# BUZZ/RATTLE FROM DOOR PANEL WHEN OPERATING AUDIO SYSTEM—VEHICLES BUILT BEFORE 8/2/2007

TSB 07-17-6

**FORD:**  
2005-2008 Mustang

Figure 1 - Article 07-17-6

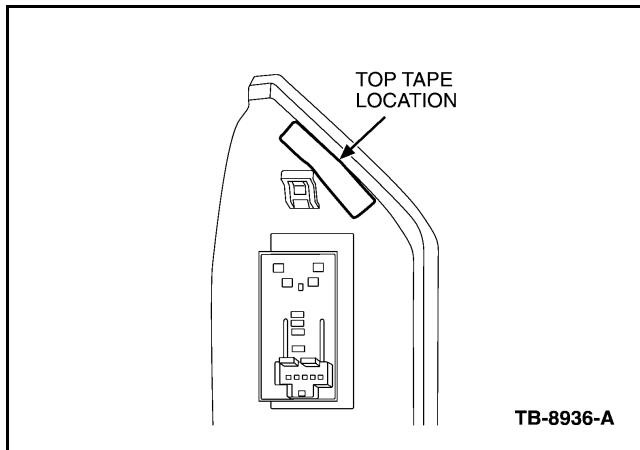
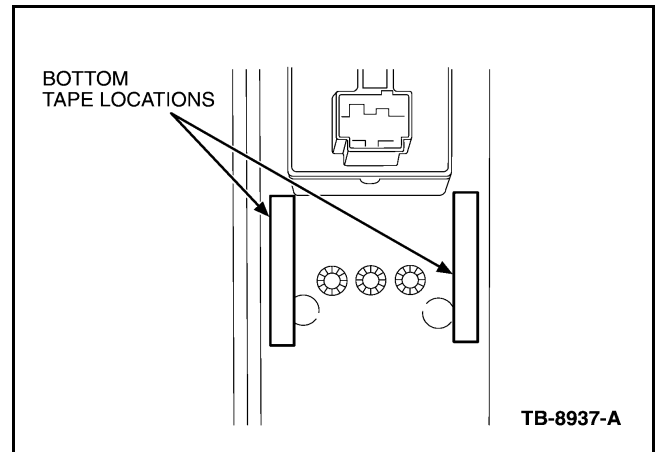
Some 2005-2008 Mustang vehicles built before 8/2/2007 may experience a buzz/rattle from the door panels when using the radio/CD player at elevated volumes or bass levels or voice broadcasts. This may be due to the window switch bezel vibrating against the door trim panel. This can often be incorrectly diagnosed as an audio speaker buzz or a bad speaker.

1. Remove window switch bezel from door panel and separate the two piece bezel.
2. Install three (3) pieces of PVC soft foam tape 3/8" wide by 1 3/4" long (10 mm by 45 mm) part number 164-R4901 from the Rotunda Squeak and Rattle Repair Kit part number 164-R4900. (Figures 1 and 2)
